Reference: Bear Claw II Exterior Remodel
RE: Ski Entry Slab Repair
2420 Ski Trail Lane
Steamboat Springs, CO
Anthem Job No. 17-173

As requested, Anthem came to the site on Tuesday, August 6th to observe the cut concrete edge at the Ski Entry on the north side of the building and how the existing condition corresponds to the repair detail Anthem issued on July 12, 2019.

Exhibit B:

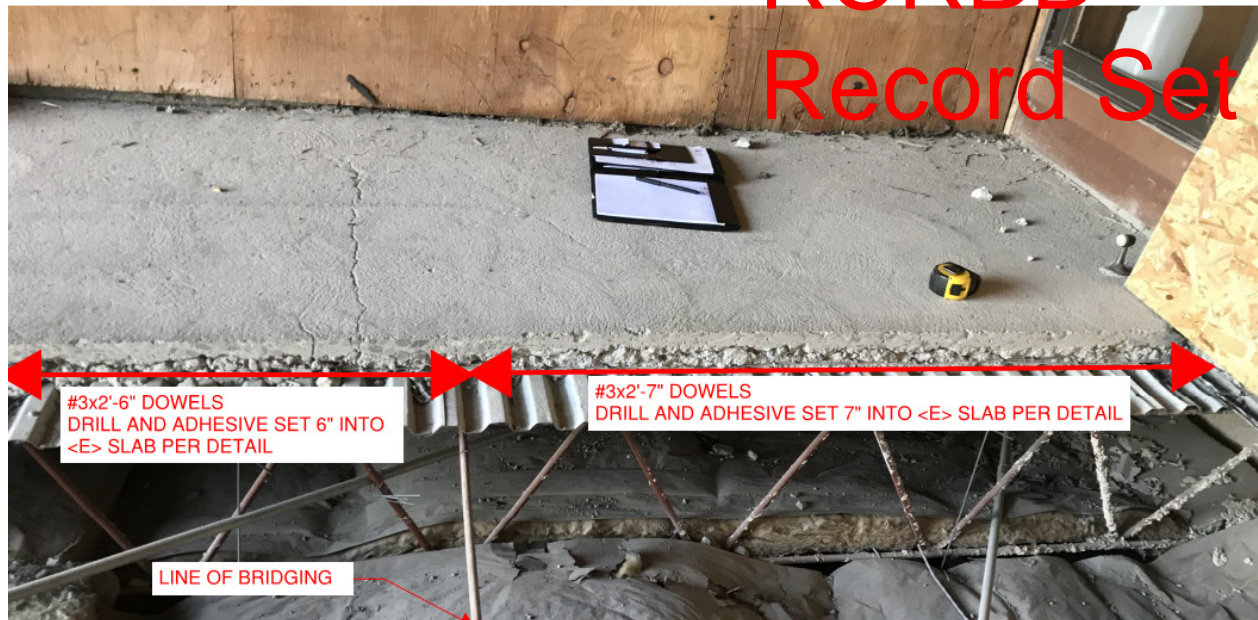
It is our opinion, that given the observed horizontal cracking within the slab section, the #3 dowel bars noted in the issued detail should extend an additional distance into the slab. The attached Exhibit A specifies our recommended embedment lengths of the new dowels. Exhibit B is an updated detail sketch of the repair.

Since we cannot observe anything other than surficial cracking, it is recommended that the Contractor contact Anthem in the event this crack is discovered to extend any further into the slab than the approximate 2" observed. The soundness of the concrete beyond the surface should be apparent during hammer drilling operations.
